Validation report form for validation of voluntary project activities Gold Standard for Global Goals		
KEY PROJECT INFORMATION		
Title and GS reference number of the programme of activities (PoA)	GS 12600: Clean Water : Clean Cooking	
Version number of the validation report	1.4	
Completion date of the validation report	03/07/2026	
Title and reference number of each VPA to be included	VPA Ref. no.	Title
	GS23369	GS12600 VPA-5 Improved Cooking: Madagascar
	GS23370	GS12600 VPA-6 Improved Cooking: Madagascar
	GS23409	GS12600 VPA-7 Improved Cooking: Madagascar
Title and GS ID of the real-case VPA	GS 12851: GS12600 VPA-3 Improved Cooking: Madagascar	
Version numbers of the VPA-DD to which this report applies	VPA 5: Version 1.9 (02/07/2026) VPA 6: Version 1.9 (02/07/2026) VPA 7: Version 1.9 (02/07/2026)	
Applied methodologies and standardized baselines for each CPA	VPA no.	Applied methodologies
	VPA 5 VPA 6 VPA 7	Reduced emissions from cooking and heating – Technologies and Practices to Displace Decentralised Thermal Energy Consumption (TPDDTEC), version 4.0

Other Requirements	Gender Equality Requirements and Guidelines V2.0 Usage Rate Guidelines V2.0 Programme of Activity requirements a

19. Maps, where required shall include:

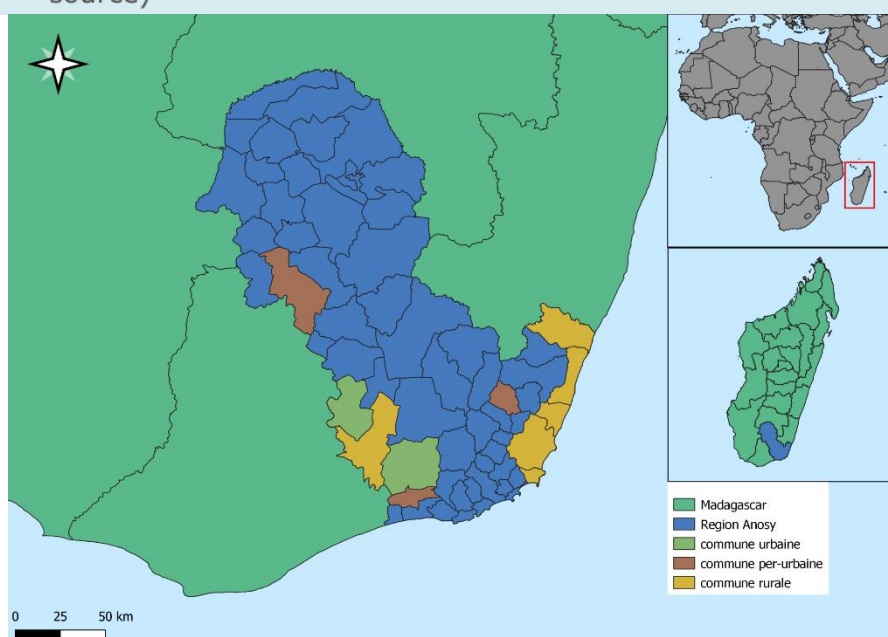
1. In Section A.2 of the VPA-DD, the project location and coordinates provided (Fort Dauphin, Anosy Region, Madagascar at 25.0225°S, 46.9854°E) are the same as in other VPAs (VPA 5, 6 & 7) therefore, the PD is requested to clarify how unique boundaries and household allocations are defined to ensure there is no overlap or double counting within the Anosy Region.
2. In section A.2, PD is requested to include the Name and ID of the project in the map including the GPS coordinate system (e.g. WGS 84) and GPS grid. Based on the below screenshot from GS PoA-DD Template Form Version 2.2 dated 14/04/2023 wherein it has been mentioned under point number 19:

- (a) Name of the project
- (b) ID of the project
- (c) Legend
- (d) Printing date
- (e) Scale
- (f) Direction of North
- (g) GPS coordinate system (e.g. WGS 84)
- (h) GPS grid
- (i) Infrastructure (roads, houses, etc.) and rivers
- (j) Information on the satellite or aerial picture (date, resolutions, data source)

2. The detailed map information, such as GPS coordinates and GPS grid, are more relevant to LUF projects. This map demonstrates the project area. CME has added the GPS coordinates of the Anosy region to sA.2 of the VPA-DDs.

2. As per assessment of revised VPA-DDs (VPA 5, 6, 7) and CME's response, it has been observed that the GPS Coordinates of the region Anosy, Madagascar has been added and is found to be acceptable. **CLOSED**
